REVIEWER COMMENTS

The manuscript "A flexible ultrasensitive optoelectronic sensor array for neuromorphic vision system" presents a study ranging from optoelectronic sensor device to neuromorphic vision systems. By using a perovskite/CNTs blend as the electro-photoactive layer, the transistor devices exhibit a high sensitivity to optical input, and can simultaneously complete signal sensing and processing tasks. Additional, a flexible sensor array was prepared and employed for neuromorphic vision systems. The combination of carbon nanotubes and perovskite quantum dots contribute to the extraordinary sensitivity to light. The fascinating 32*32 integrated sensor array enables the demonstration of an efficient neuromorphic vision system based on this realistic sensor array. The manuscript is well written and the figures are clearly constructed. I recommend publication in Nature Communications with major revisions, the authors should consider the following comments:

Figure R1 Characterization of $CsPbBr_3$-QD size. (a) AFM image of a $CsPbBr_3$-QD film (scale bar, 500 nm). (b) Histogram of the statistical distribution of the size of $CsPbBr_3$-QDs. (c) TEM image of $CsPbBr_3$-QDs (scale bar, 40 nm).

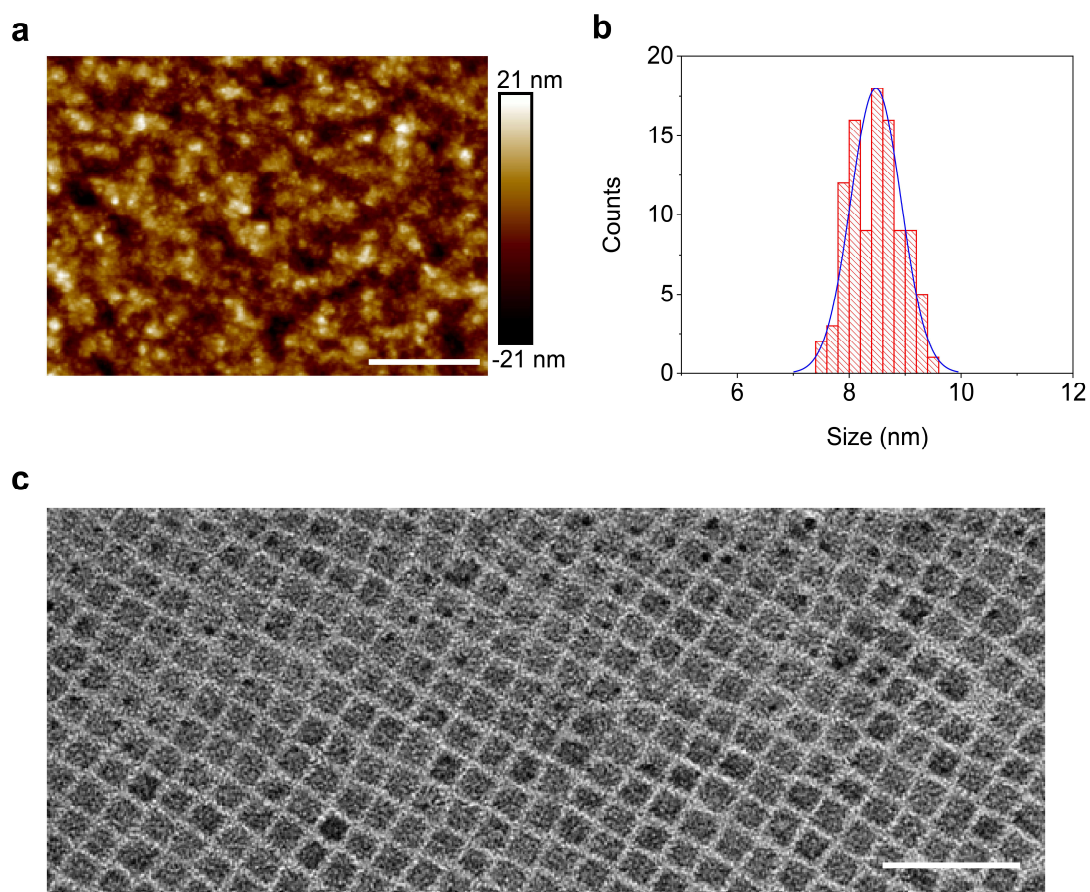
1. In this study, the $CsPbBr_3$-QDs was used as photon absorption unit. While, in Figure 1c, according to the scale bar (2 μm), the particle size is around 100 nm, which is much larger than the size of quantum dots (typically 2-20 nm). Does QD aggregate? Additional, are the $CsPbBr_3$ distributed on the surface, in the bulk, or at the bottom of CNTs? The distribution of $CsPbBr_3$ can obviously affect the optoelectronic properties.

We thank the reviewer for the valuable comments. In the original submission, the atomic force microscope (AFM) image of $CsPbBr_3$-QD film provided was not clear due to the large scanning range. Figure R1a shows the AFM image of the $CsPbBr_3$-QD film with a relatively smaller scanning range, indicating a small particle size. Figures R1b and R1c show the accurate size of $CsPbBr_3$-QD with a mean size of ~8.5 nm, which is characterized by the transmission electron microscope (TEM).

Figure R7 I_{DS}-V_{GS} characteristics of CsPbBr$_3$-QD transistor. V_{DS} = 1 V, λ= 405 nm.

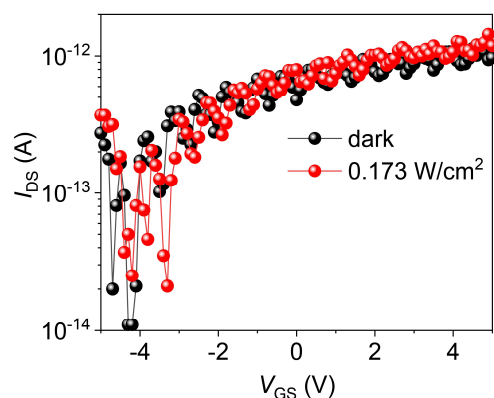
1. It can be seen from the manuscript that the photocarriers of perovskite quantum dot film are only transferred between carbon nanotube layer and perovskite quantum dot layer, which means that the perovskite quantum dot film in the channel is not conductive. In order to prove that the mechanism is correct, the author should provide some representative data in terms of the conductivity in the horizontal direction of the perovskite quantum dot film.

Figure R7 shows the transfer (I_{DS}-V_{GS}) characteristics of the CsPbBr$_3$-QD

transistor under dark and illuminated conditions. The sub-picoampere current close to the noise level indicates that the CsPbBr$_3$-QD film is not conductive in the horizontal direction.

Figure R8 Light-dose-dependent response of the phototransistor at various lighting power densities. The device not only exhibits a time-dependent response, but also light-intensity-dependent characteristics. $V_{DS} = 1$ V, $V_{GS} = 5$ V, $\lambda = 405$ nm.

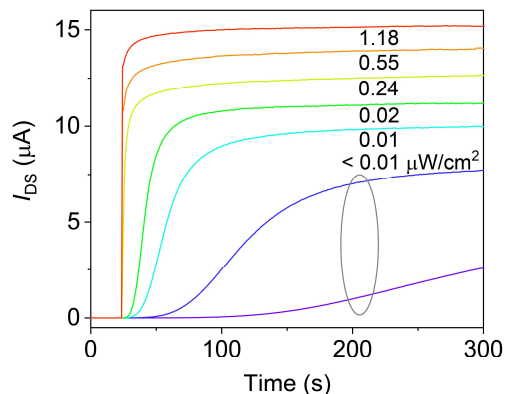
2. According to supplementary Figs. 9a and 14b, can we infer that the phototransistor can response to a weaker light with a power density lower than 0.01 uW/cm^2? If so, it is better to give a response curve with weaker light to prove the authors' claim of ultrasensitive characters.

We try our best to carry out the measurement under extra-weak lighting environment. Figure R8 shows that the photodetector can response to a weaker light with a lighting power density lower than 0.01 µW/cm^2, which is the limited resolution of our current measurement equipment.

Figure R12 Light-intensity-dependent synaptic plasticity with a pulse width of 20 ms. $V_{DS} = 1$ V, $\lambda = 516$ nm.

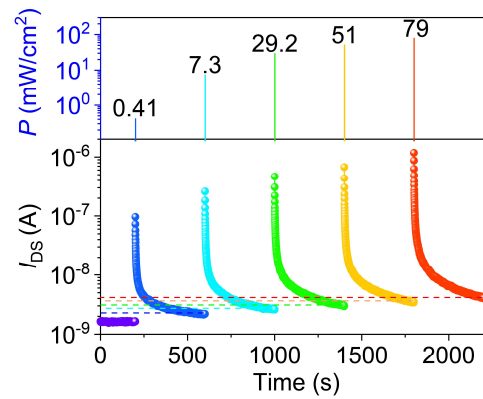
8. In the top panel of Supplementary Fig. 16, I think lighting power density on the vertical y-axis corresponds to the time on the horizontal x-axis, but the values of the power density are denoted on the x-axis, please correct it to avoid misunderstanding for readers.

Thanks for your question. The previous statement in the original submission was

unclear, which caused readers to misunderstand. According to the reviewer's suggestion,

we corrected the positions of the power density.

Figure R13 Morphology and CNT length distribution of semiconducting-CNT film. (a) SEM image of semiconducting-CNT film with a deposition time of 30 minutes (scale bar, 1 μm). (b) Histogram of statistical distribution of the length of semiconducting-CNTs.

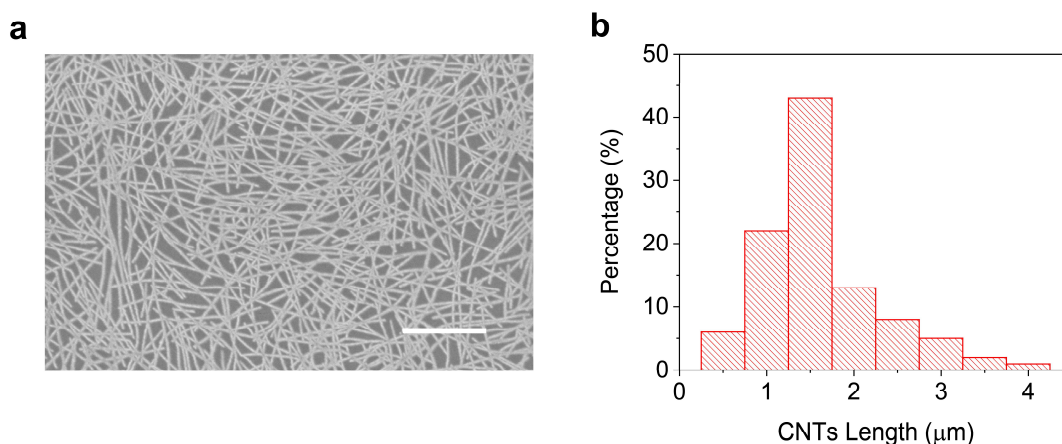
2. The size and dimension of CNTs are missing. The description and nature of CNTs (single- or multi-wall) is important to discuss.

The raw arc-discharge CNT purchased from Carbon Solution Inc.

(https://carbonsolution.com/products/ap-swnt) has a narrow diameter distribution with a peak value of 1.55 ± 0.1 nm and a bundle length of 1-5 μm. Furthermore, high-purity (>99.9%) semiconducting-CNTs were sorted by mixing these bulk CNTs in a xylene solution, followed by ultrasonic stirring, and then centrifuging to remove CNT bundles and insoluble substances. We measured the CNT length based on a low-density CNT film on a SiO$_2$/Si substrate. Figure R13 shows the morphology of the sparse CNT network and a mean length of the CNTs is 1.4 μm based on the statistical analysis of the length distribution.

Figure R17 I_{DS}-V_{GS} curves of the CNT/CsPbBr$_3$-QD phototransistor under dark and

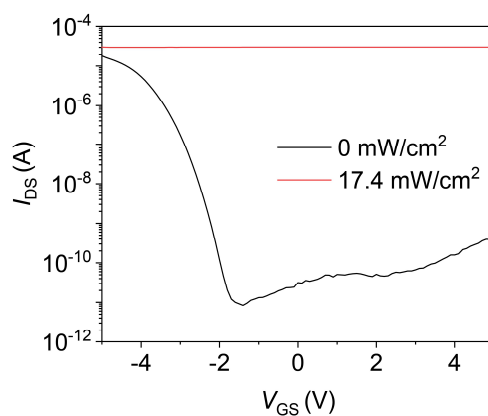
7. The current on-off ratio in Figure 1d does not look like $\sim 10^7$ (in dark and under light).

We fully agree with your valuable comments. Indeed, the accurate value of the on- and off-current ratio is re-evaluated to be 3.6×10^6, which is slightly less than 10^7, as shown in Fig. R17.

Figure R22 Light-dose-dependent response of the phototransistor at various lighting power densities. The device not only exhibits a time-dependent response, but also light-intensity-dependent characteristics. V_{DS} = 1 V, V_{GS} = 5 V, λ = 405 nm.

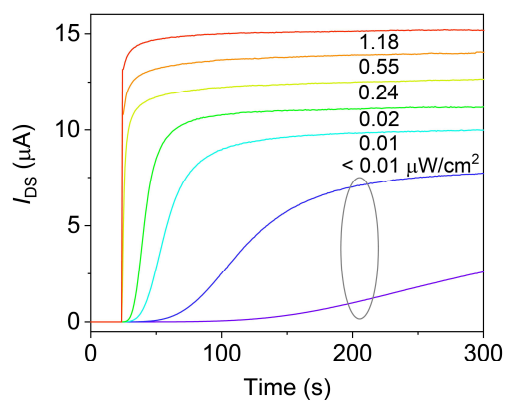
13. In Figure S8, what is the time period of light irradiation?

The light-dose-dependent response includes time dependence and light intensity dependence. For the time-dependent characteristics, as the light irradiation time is extended, the photocurrent of the phototransistor increases and reaches saturation after a sufficient illumination duration. These phenomena can also be observed in the literature (F. Zhou, et al, Nat. Nanotechnol., 14, 776-782, 2019; X. Liu, et al, Nat. commun., 5, 4007, 2014). Figure R22 shows the time-dependent characteristics of the phototransistor at various lighting power densities during an illumination duration of 275 s, which indicates that the I_{DS} will reach a saturation value as the illumination continues.

Figure R26 Noise power density (S_n) of the phototransistor showing a strong 1/f component measured at a frequency of 1 Hz. $S_n = 1.3\times10^{-22}$ A^2/Hz. $V_{\text{DS}} = 1$ V, $V_{\text{GS}} = 5$ V.

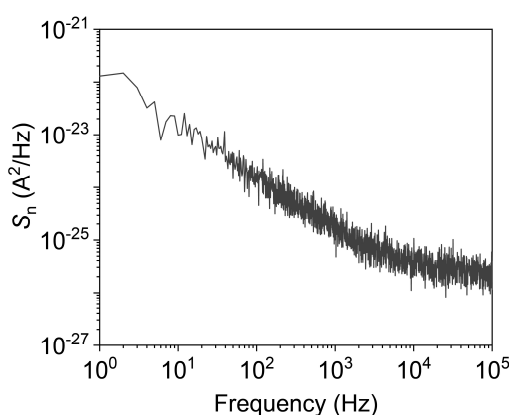
18. [IMPORTANT] I am not sure that the detectivity values provided by the authors are actually valid. There is a big miss-interpretation in the 2D community where the formula for shot-noise limited detectors is always used despite the fact that this might not be the case. See:

Thanks for your valuable comments. Indeed, the characteristics of noise power density are very important for comprehensive and accurate device performance evaluation. As the reviewer pointed out, for the devices made of recent emerging semiconductors (such as perovskites, 2D materials or organics), sometimes the noise density was underestimated and therefore the detectivity of device was overestimated. In this case, it is assumed that the noise power density is independent of frequency and equal to shot-noise, but it is actually NOT correct.

However, in our original submission, we have performed noise measurements and extracted dark noise currents for a correct evaluation of device performance. Figure R26 shows the measured noise power density ($\sqrt{S_n}=1.14 \times 10^{-11}$ A/Hz$^{1/2}$), which

indicating that the 1/f (flicker) noise is dominant, and the specific detectivity of our phototransistor was evaluated to be 2×10^{16} Jones. On the other hand, if only the shot-noise is used for evaluation, ($\sqrt{2eI_{\text{dark}}}=1.79\times10^{-14}$ A/Hz$^{1/2}$), the obtained detectivity (1.3×10^{19} Jones) will be overestimated by three orders of magnitude higher than the actual situation. Therefore, we state that, in our research, the evaluation of device performance parameter is based on scientific judgment.

Figure R1 Measured training weight results of the sensor array after training with 10 pulses under a 405 nm light with various lighting power densities of 4.0 μW/cm², 0.3 mW/cm², 1.0 mW/cm², 2.5 mW/cm² and 4.0 mW/cm² (pulse width, 250 ms; pulse interval, 250 ms).

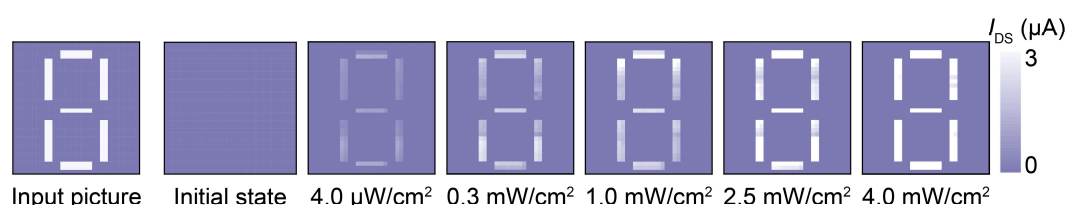
1. In Figure 3 (Revised manuscript), it is recommended to provide the impact of different light power on image quality.

According to your valuable suggestion, we have measured the weight map of the sensor array after training with 10 pulses under a 405 nm light with various lighting power densities (Fig. R1). The weight map shows different resemblance degrees and image sharpness compared with the input number "8" pattern, indicating that higher lighting power density can speed up the pattern learning process.
